Technical Service Bulletin

66 Wind noise from exterior rear view mirror

66 15 52 2035673/5 April 30, 2015. Supersedes Technical Service Bulletin Group 66 number 15-50 dated April 10, 2015 for reasons listed below.

Figure 6. Area where felt tape is to be applied (A).

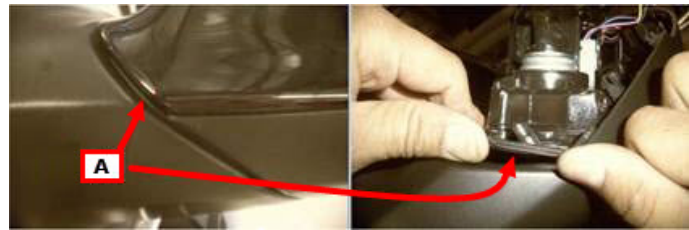
6. Apply the felt tape strips to the area of the mirror base between the mirror base and the seal, as shown at right (Figure 6). This will provide tension to the seal limiting the possibility of seal vibration at high speeds.
